## Photocontrol Response Time during Installation Testing

**Subject** Evluma AreaMax Integrated Photocontrol Response Time during Installation Testing

*photocontrol before 9/1/2015*

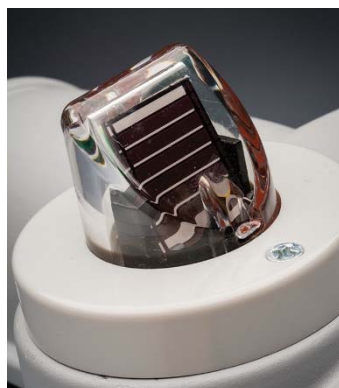
Response times during the installation testing of all market available photocontrols vary based on pre-installation lighting conditions. Because Evluma integrated photocontrols on AreaMax shipped after September 1, 2015 appear differently (see images below) from previously shipped units, observed changes in photocontrol response times may translate to a quality concern on the part the installer.

When an outdoor luminaire with dusk-till-dawn functionality is installed, it is common practice for the installer to place a gloved hand over the photocontrol to confirm that the photocontrol and luminaire are energized and in good operating condition. The level of light that the photocontrol is exposed to prior to being covered for the test affects the turn-on delay, so does the amount of light leaking through the installer's glove. For most photocontrols a capacitor stores light energy as a safety precaution against rapid changes in lighting, such as clouds passing or headlights. This maintains the consistent, safe operation of the luminaire. When tested under a variety of light levels, Evluma's integrated photocontrol may take anywhere from 10 seconds to 2 minutes to energize the AreaMax.

At installation, every model of the AreaMax will flash when connected to power. This flash indicates that the AreaMax is functioning properly. A red LED light located at the edge of the white internal reflector also serves to indicate that the AreaMax is connected to power. This small red LED light may be hard to see in bright sunlight.

It is not necessary to perform a “glove test” on AreaMax models with the integrated photocontrol. If this is the preferred method of testing, please allow up to two minutes for the photocontrol to energize the light. When testing the photocontrol, confirm the access panel is closed to prevent light from coming in through the panel opening.
